DESIGN REVIEW COMMITTEE

February 18, 2026 6:00 PM

AGENDA

PROPOSED WINDOW DESIGN CHANGES

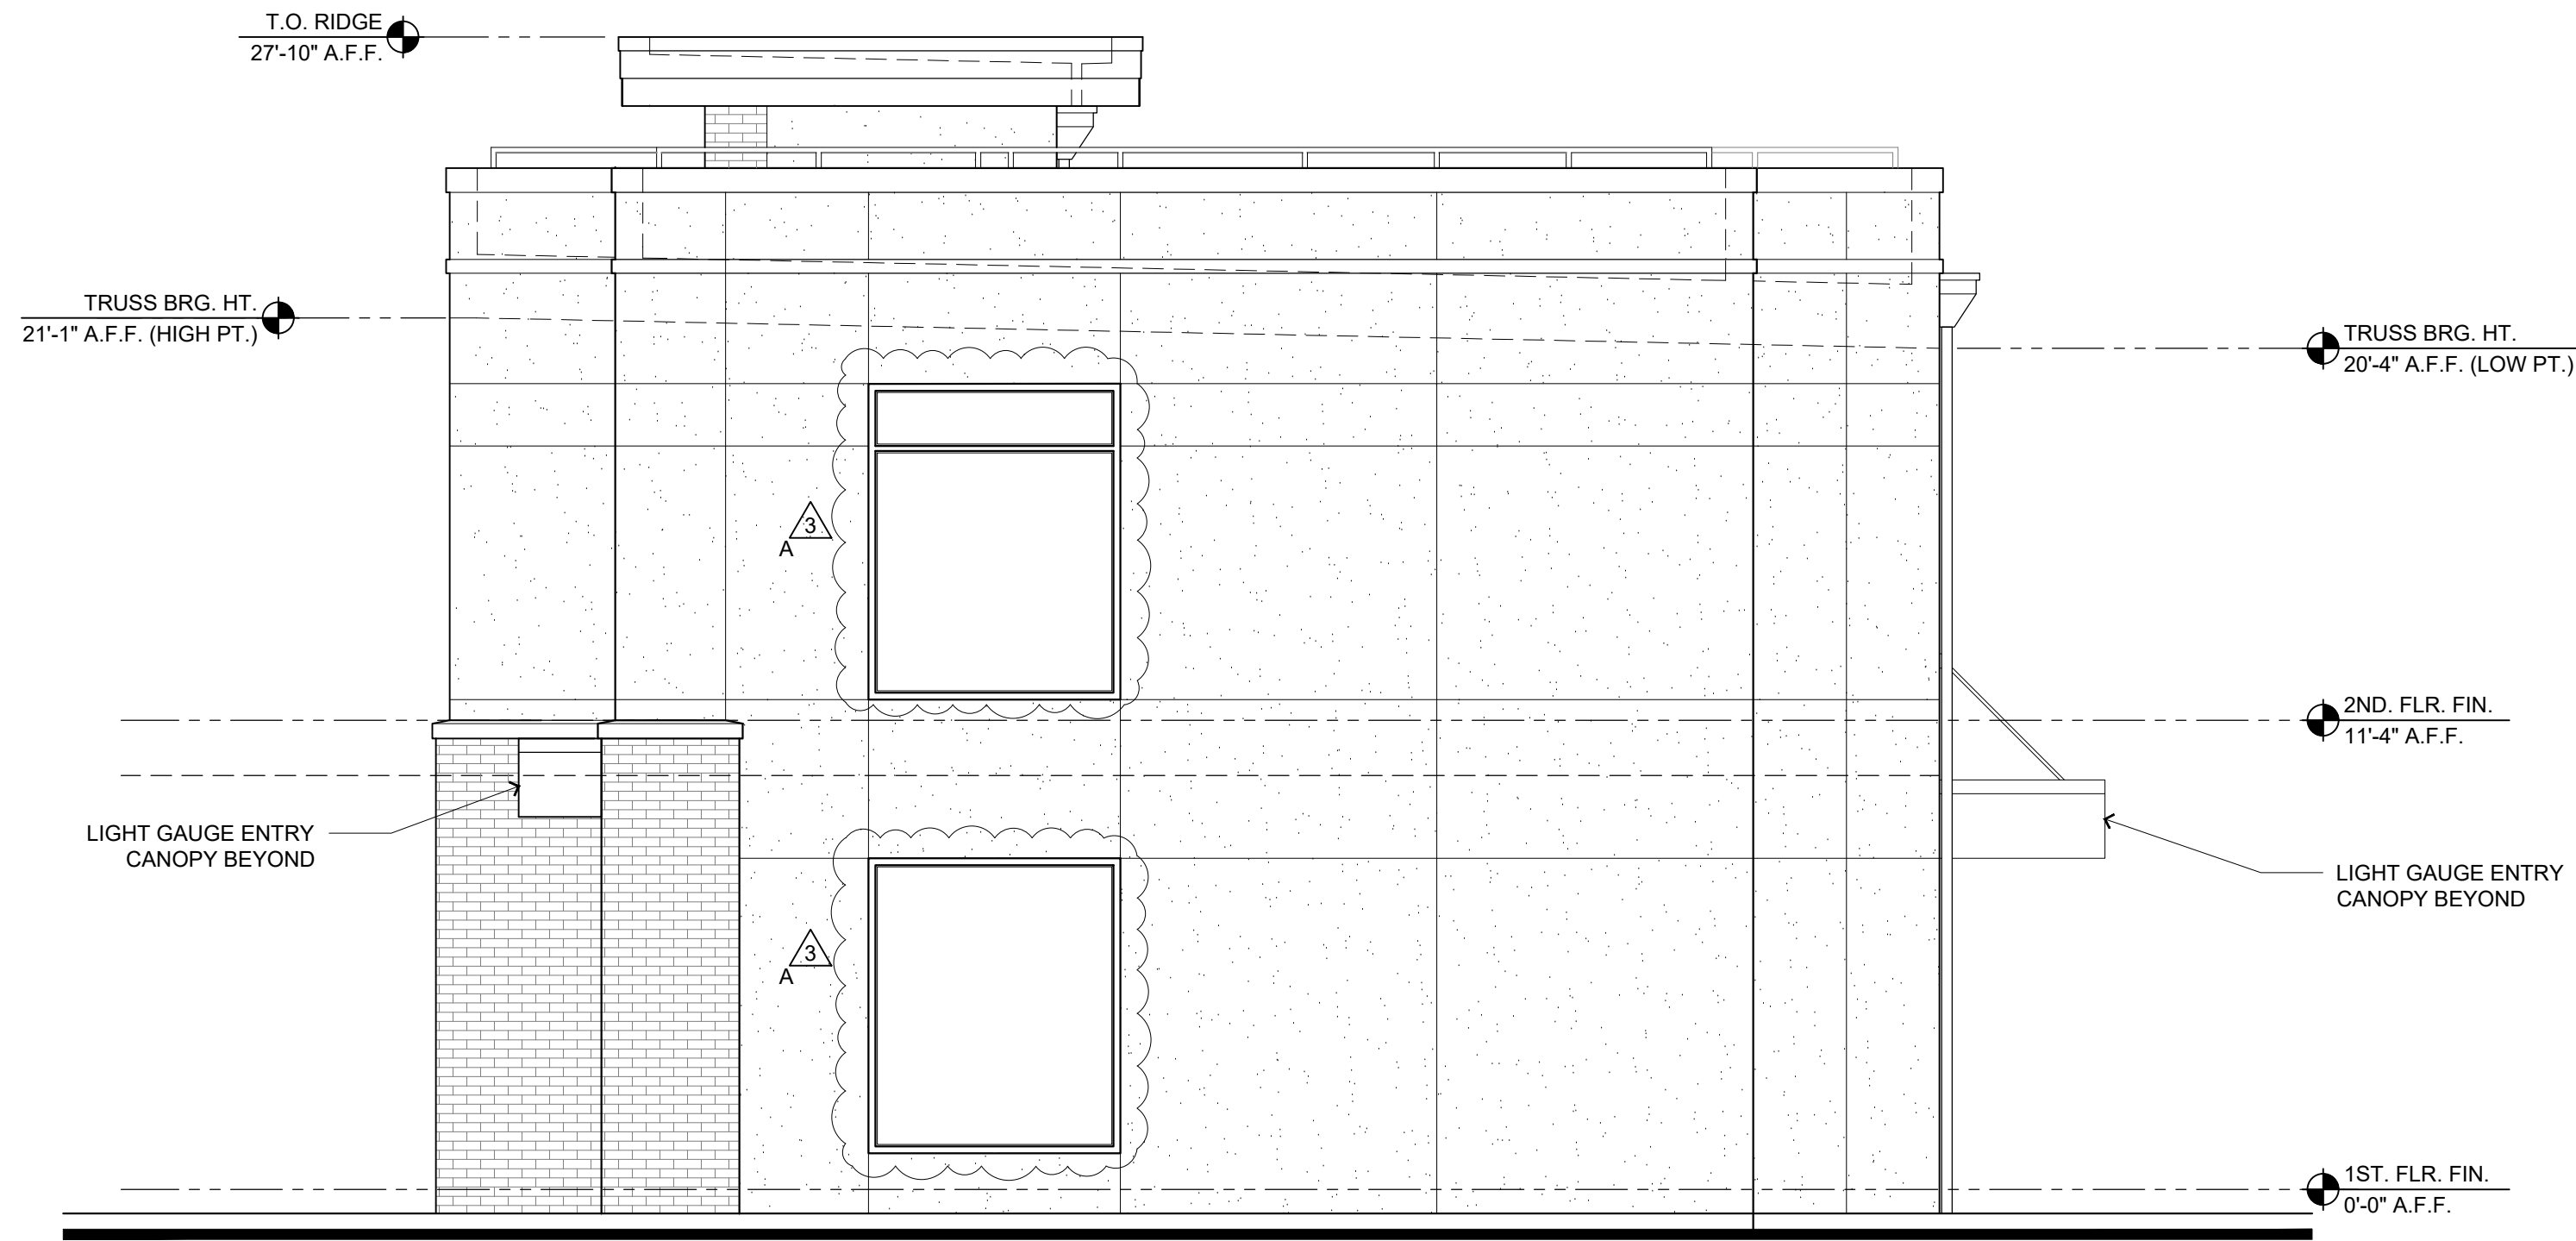
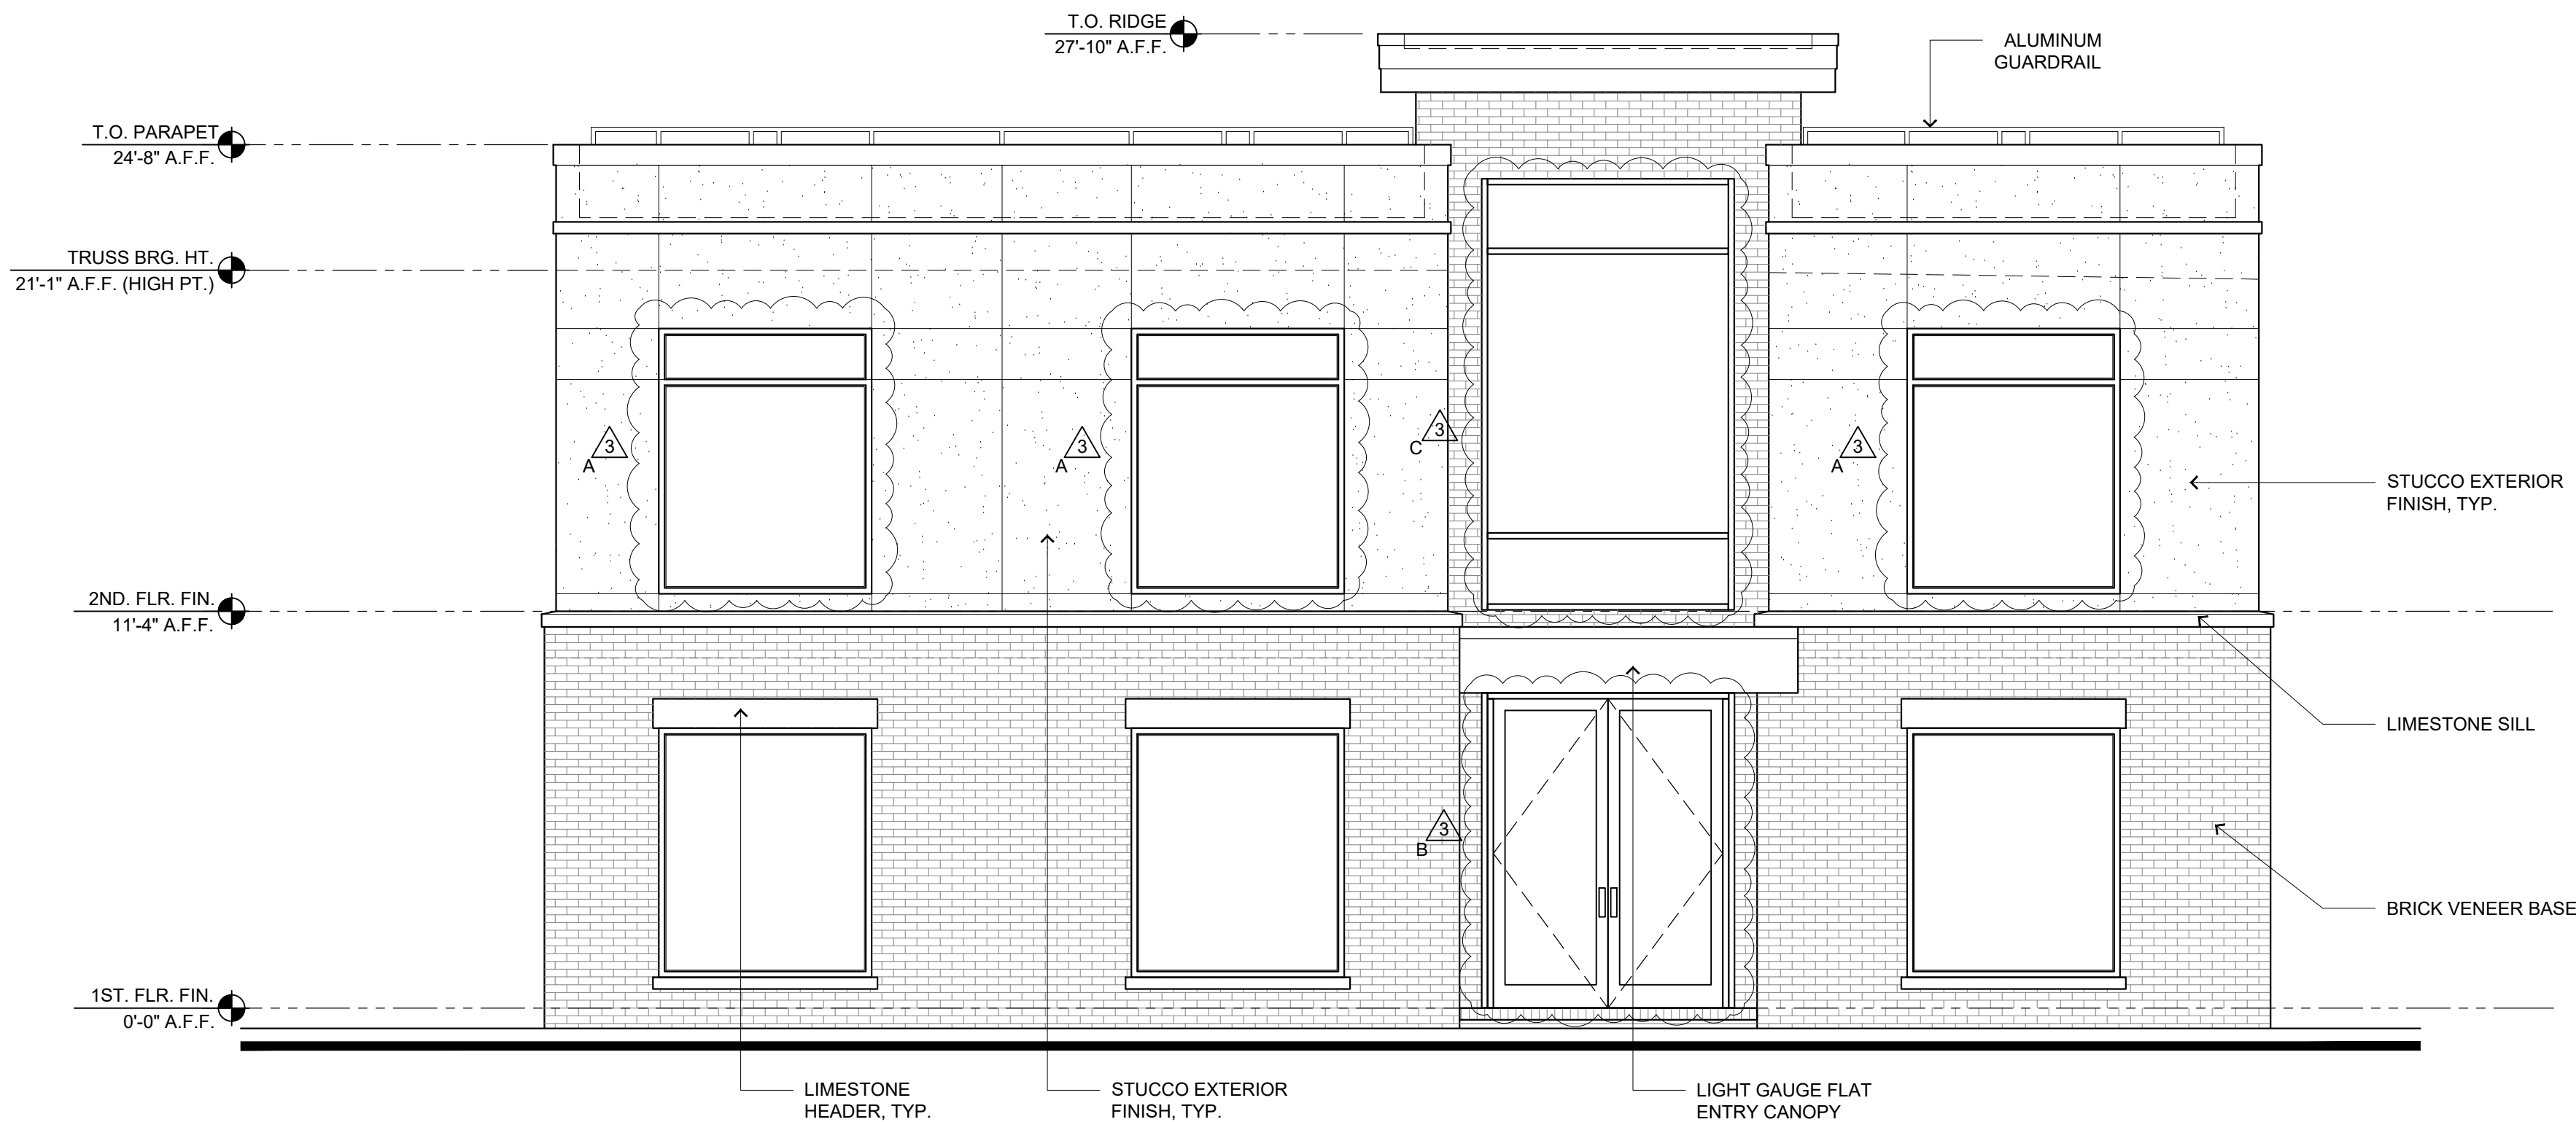
The requested change is to modify the windows from divided light windows to large pane windows on the lower and upper floors and to install transoms on the upper story windows. The applicant has also removed the grid from the center window and is proposing three separate panes (is it unclear if this is one large pane with applied horizontal muntins or three separate panes). Finally, the single door with sidelights and transoms is proposed to be replaced with a double door with glass and no transom.

The applicant appeared before the Design Review Committee in January 2026 and was asked to return with an alternative plan as the windows were not oriented vertically as required by Code. As Mr. Harris stated at the meeting that the windows had been ordered, a recommendation from a Committee member during the meeting was to bring by a design to address verticality that included realigning the lower windows and adding transoms to align with the front door and adding transoms to the upper window. This was not a conditioned approval but rather an opportunity for the applicant to provide a design that addressed the required verticality.

The applicant has returned with an alternative design that adds only transoms to the upper-story windows to achieve verticality. The Architectural Design Standards require that upper-story windows shall be vertically oriented, with a height greater than their width, including display windows but not transoms. If the proposed window modifications are acceptable to the Committee, a Design Exception would be required.

The Design Review Committee may assess whether the revised windows meet the intent of the storefront treatment as prescribed in the Standards.

REVISION #3
A. ADDED TRANSOM
B. REVISED ENTRY DOOR UNIT
C. REVISED WINDOW MULLIONS

REVISION #2
A. REMOVED WINDOW MUNTINS
